## Addendum No. 1

Temporary Shelters Project  
RFP No. 2001-DD

January 24, 2020

## TEMPORARY HOMELESS SHELTER SAMPLE CABIN LAYOUT

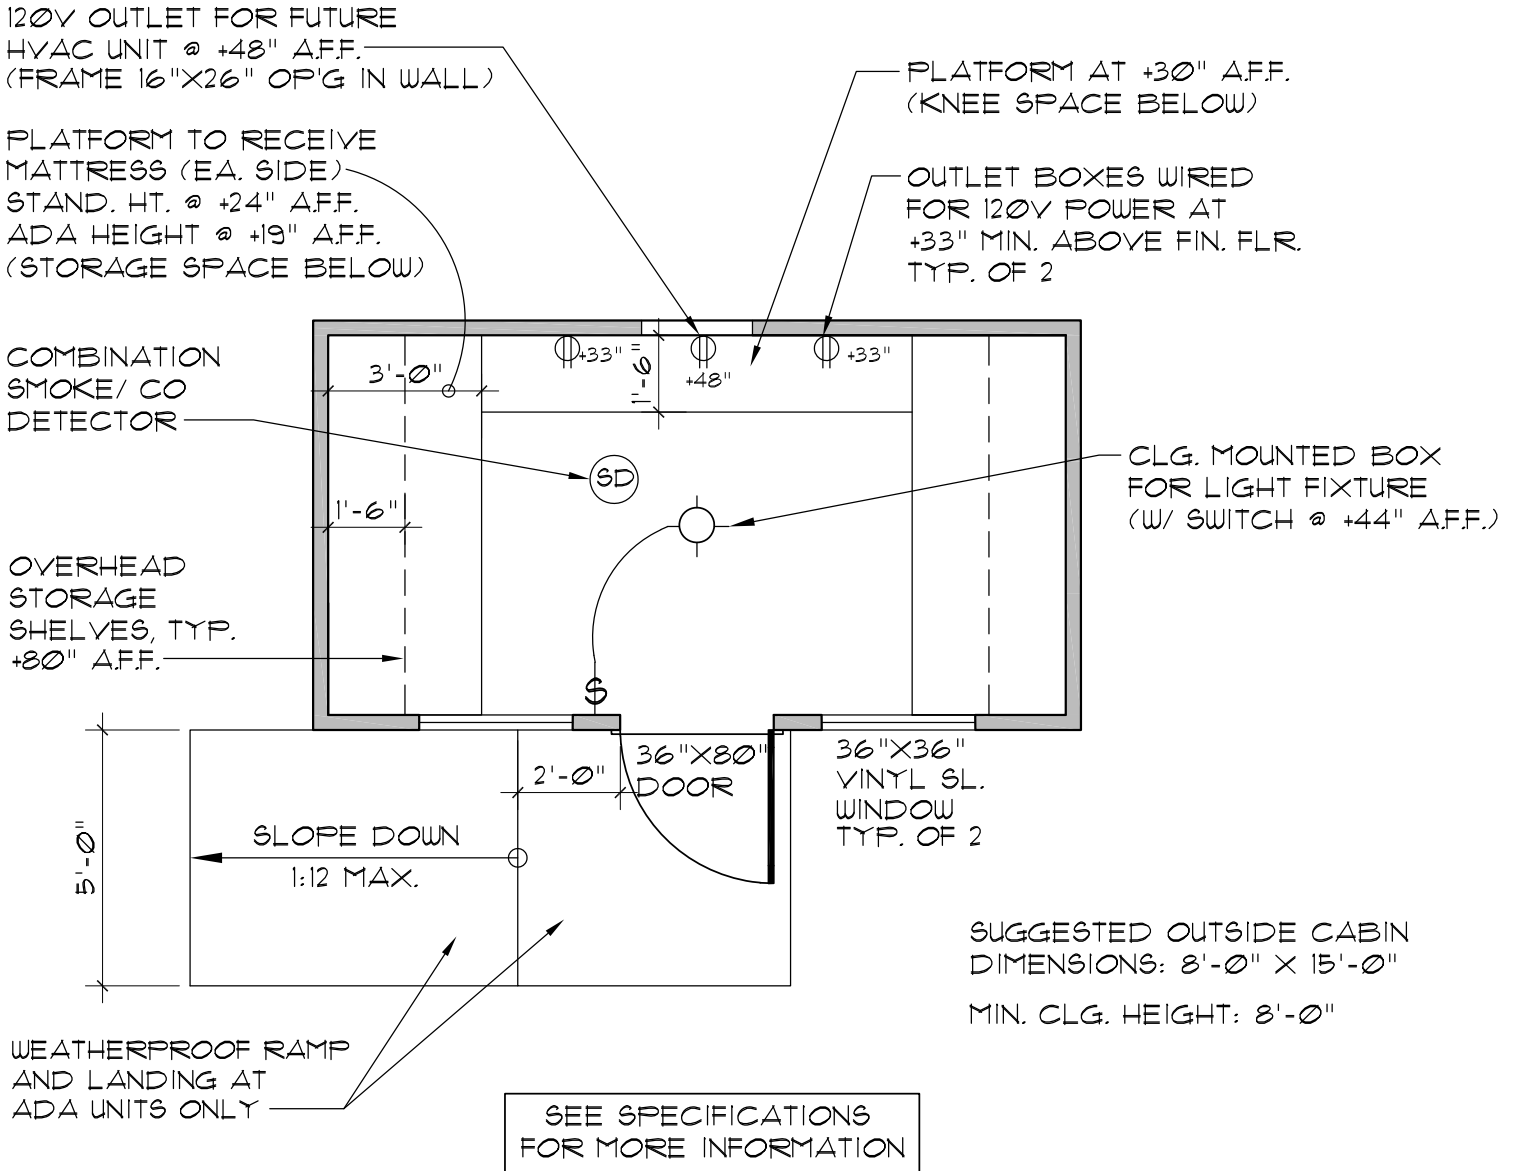
**QUESTION 13:** Is the ramp required to be a certain material or shape?

**DELETE:** Attachment A – Temporary Homeless Shelter Sample Cabin Layout

**INSERT:** Attachment A – Addendum No. 1 - Temporary Homeless Shelter Sample Cabin Layout

**ANSWER 13:** Ramps shall be wood or metal frame with durable, waterproof finish. Dimensions of the ramp are shown on Attachment A – Addendum No. 1 - Temporary Homeless Shelter Sample Cabin Layout.

- i. See Sample Cabin Layout attached for location
  - b. One 120V wired ceiling box (15 amp with minimum 14/2 wiring)
    - i. See Sample Cabin Layout attached for location

- i. See Sample Cabin Layout attached for location
  - e. Shall have provisions for connection to the grid (SMUD). Electrical homeruns shall terminate in a metal outlet box mounted on the exterior of the cabin. Agency will provide subpanel and utility connections under a separate contract.

3. Door (see plan for sample location)
  - a. One 6-panel 36"x80" insulated residential door (outswing). Preferably fiberglass skinned
  - b. Lever style entry hardware (lockable)

- c. Landing and ramp at ADA units (see plan for sample location)
4. Windows
  - a. Two 3'x3' horizontal sliding windows (one on each side of entry door)
